**ZONING AND PLATTING COMMISSION
HILL COUNTRY SITE PLAN REVIEW SHEET**

CASE NUMBER: SPC-2012-0003C **ZAP COMMISSION DATE:** May 7, 2013

PROJECT NAME: Escondera Section 4

| SHEET NO. 7 OF 39 | |

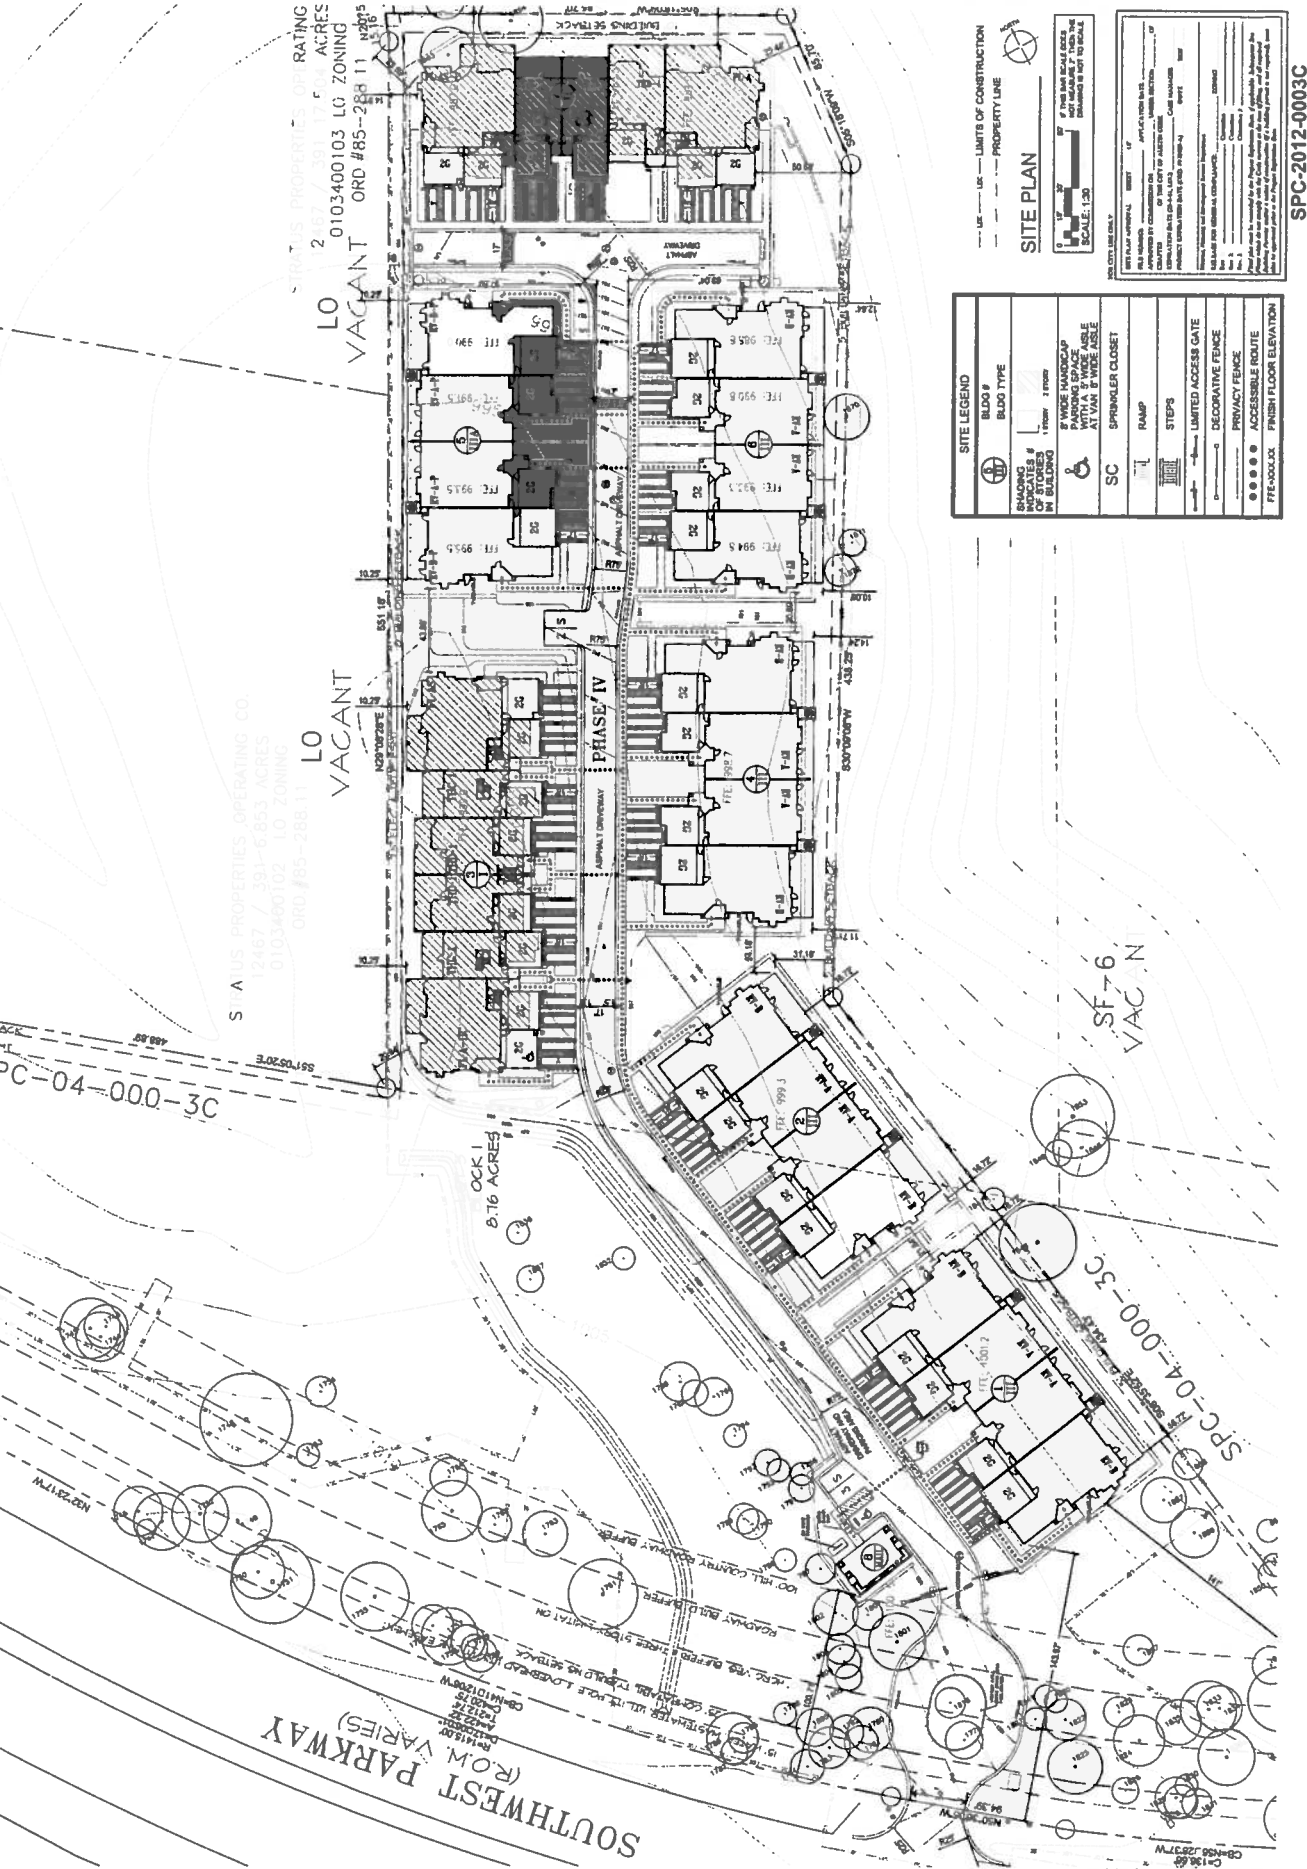
4. The proposed site plan distributed at the homeowners' meeting shows seven units at the northern end of Phase IV. Originally only four units were to be placed in this location. Adding units in this area will increase the encroachment onto an environmentally sensitive area and overload it. The number of units at the northern end of Phase IV should be limited to four.

2. The proposed site plan shows seven units at the northern end of Phase IV. In the site plan used to sell the homes in the first three phases at Escondera Townhomes, only four units were to be placed in this location. Adding units in this area will increase the encroachment onto an environmentally sensitive area and overload it. The number of units at the northern end of Phase IV should be limited to four.

This development is in the Barton Springs Zone. On the proposed site plan, the stormwater drainage sedimentation basin is located at the northeast corner of the development. This location places it close to and directly uphill from a Critical Water Quality Zone.

The sedimentation basin should be moved to the northwest corner of the development. This move would provide greater protection to the nearby Critical Water Quality Zone in that the sedimentation basin would be farther away. Furthermore, the drainage path from the location I suggest would not be directly to the Critical Water Quality Zone. Such a relocation is feasible because of topography (the sanitary sewer lift station is already proposed for the northwest corner of the development and there is sufficient room available for both there).

After reviewing the plans, I would like to add the following objection. This development is in the Barton Springs Zone. On the proposed site plan, the stormwater drainage sedimentation basin is located at the northeast corner of the development. This location places it close to and directly uphill from a Critical Water Quality Zone.

The sedimentation basin should be moved to the northwest corner of the development. This move would provide greater protection to the nearby Critical Water Quality Zone in that the sedimentation basin would be farther away. Furthermore, the drainage path from the location I suggest would not be directly to the Critical Water Quality Zone. Such a relocation is feasible because of topography (the sanitary sewer lift station is already proposed for the northwest corner of the development and there is sufficient room available for both there).
